GE Nuclear Energy

June 4, 1997

Reference: License SNM-960, Docket 70-754.

Enclosed are replacement pages to Appendix A, "License Conditions for the Vallecitos Nuclear Center", and Appendix B, "Demonstration for Special Nuclear Material License Renewal for the Vallecitos Nuclear Center", to our current License SNM-960. These pages amend, delete and replace the existing pages in the subject document. The purposes of these changes are to correct typographical errors, update organizational changes, and update the organization chart and personnel resumés.

FIGURE 2.1. VALLECITOS NUCLEAR CENTER ADMINISTRATIVE ORGANIZATION CHART  
(Components shown below the dotted line are located at VNC)

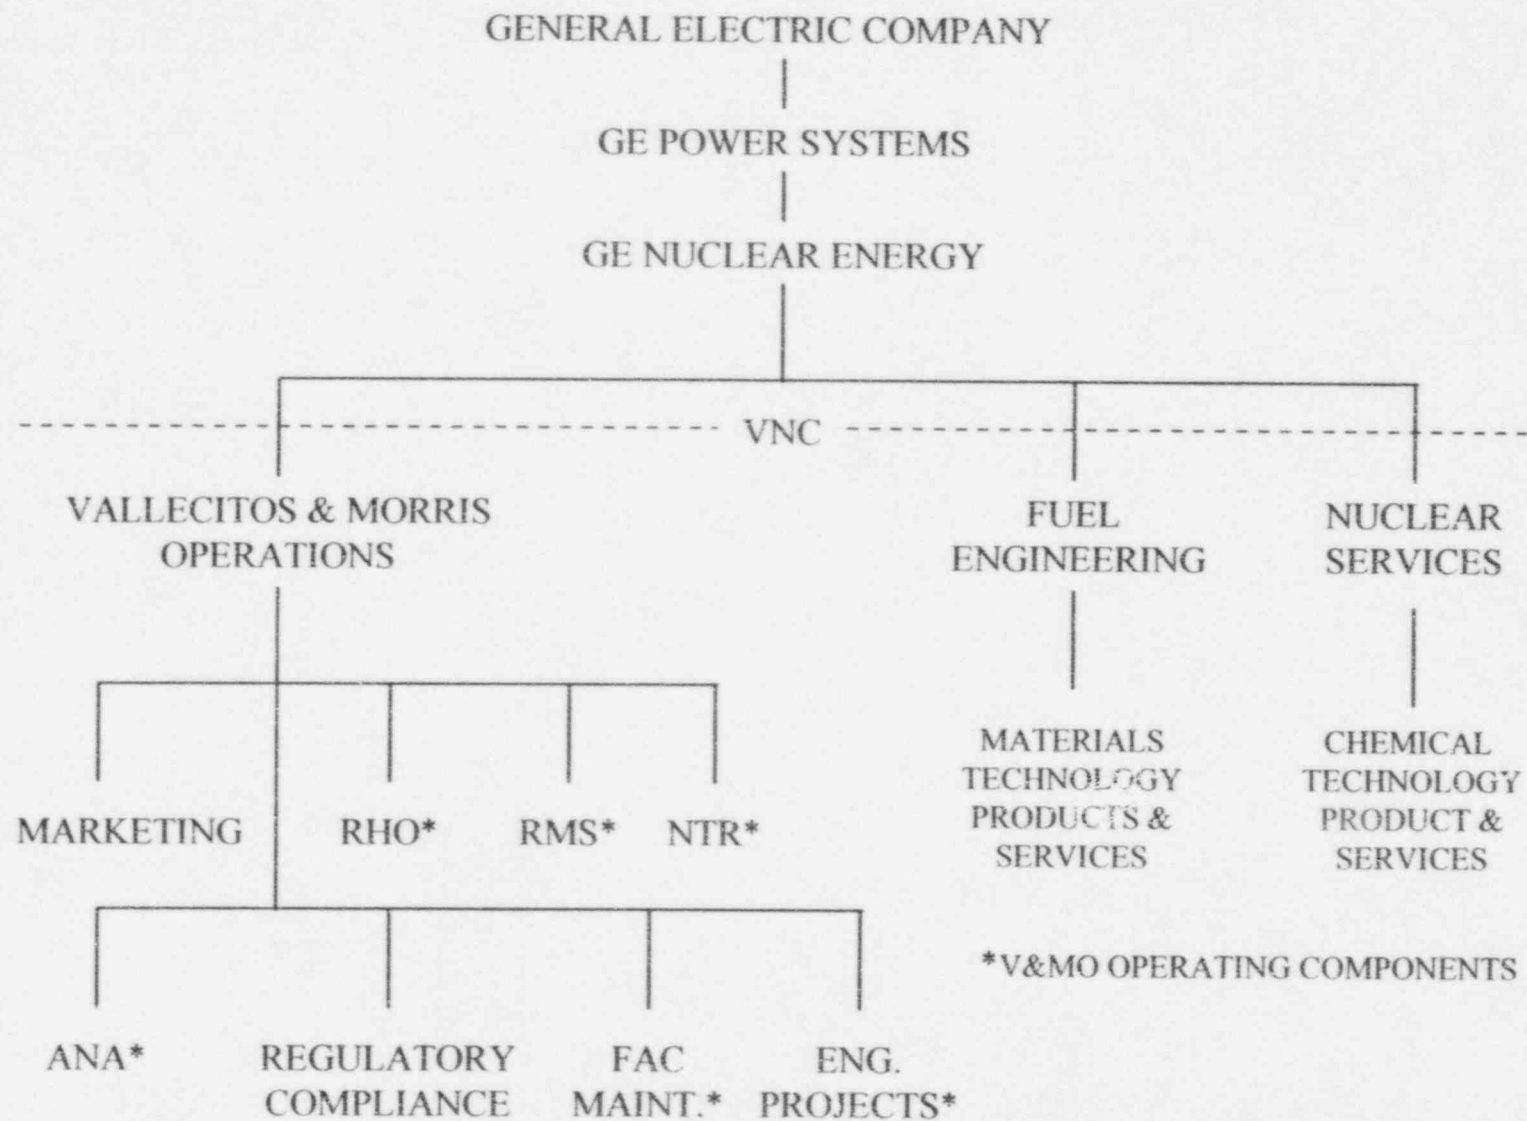
- App. B, Sect. 2.0, p. 2-14  
Replace Figure 2.1, "Vallecitos Nuclear Center Administrative Organization Chart".
- App. B, Sect. 2.0, p. 2-15  
Replace Figure 2.2, "Nuclear Safety Organization".

FIGURE 2.3 RADIATION SAFETY STRUCTURE

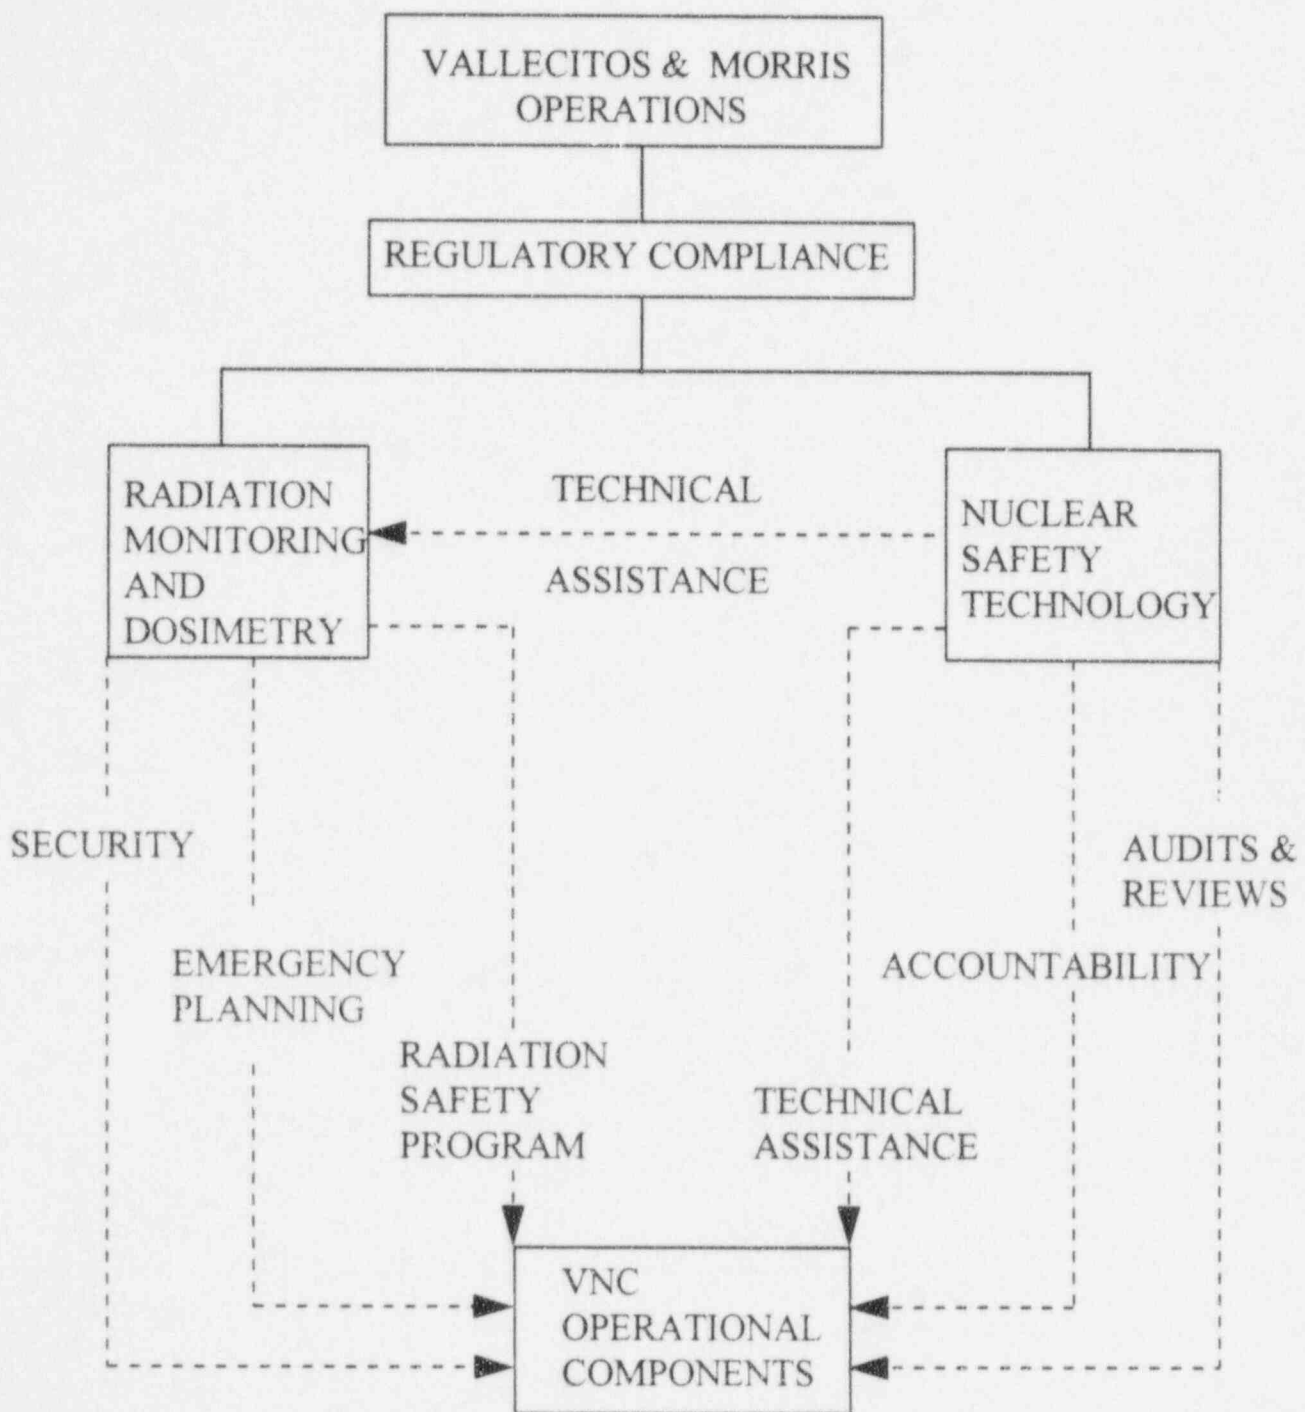
- App. B, Sect. 2.0, p. 2-16  
Replace Figure 2.3, "Radiation Safety Structure".
- App. B, Sect. 2.0, p. 2-17  
Replace Figure 2.4, "Criticality Safety Structure".
